NUMBER: 09-005-04

GROUP: Engine

SUBJECT:

Growling Sound On Acceleration

Fig. 1 ENGINE MOUNT

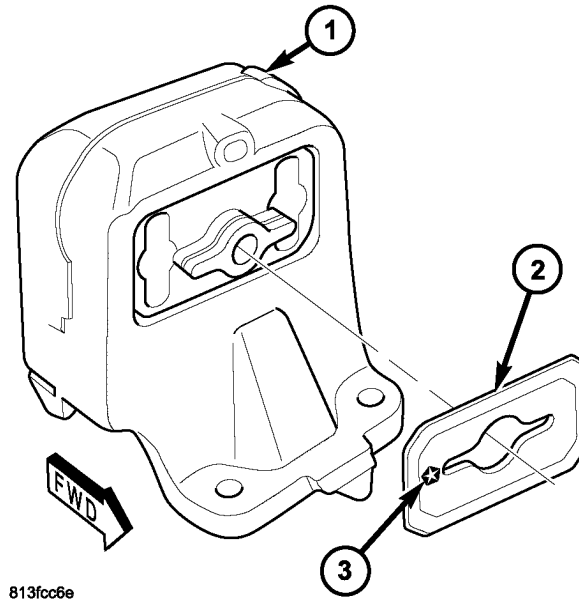
A growling or moaning sound may be present on heavy acceleration when carrying heavy loads or towing. This condition may be caused by the right motor mount contacting the motor mount frame bracket.

Inspect the right engine mount and bracket. If the motor mount is contacting the bracket, witness marks (shiny metal) will be present on the frame bracket. If the witness marks are present perform the Repair Procedure.

1. Raise the vehicle on a hoist.
2. Place an adjustable jack stand under the engine to support the engine when the motor mount through bolts are removed.
3. Loosen both motor mount through bolts. Leave the nut on the left side mount as this bolt will not be removed. Remove the nut on the right side.
4. Raise the engine with the jack stand until the right side through bolt becomes free. Remove the right side bolt. Raise the engine far enough to clear the frame bracket and allow the isolator pad, p/n 55366020AA to be inserted. Insert the isolator on the mount with the Pentastar logo facing the front of the vehicle. (Fig. 1). Lower the bracket and align the mount with the frame bracket and push the bolt through the isolator and bracket with the threads at the rear.

- 1 - Right Motor Mount
- 2 - Isolator
- 3 - Logo - Facing Front

- 5. Install the nut and tighten both through bolts to 115 Nm (85 ft. lbs.).
- 6. Remove the jack stand.
- 7. Lower the vehicle
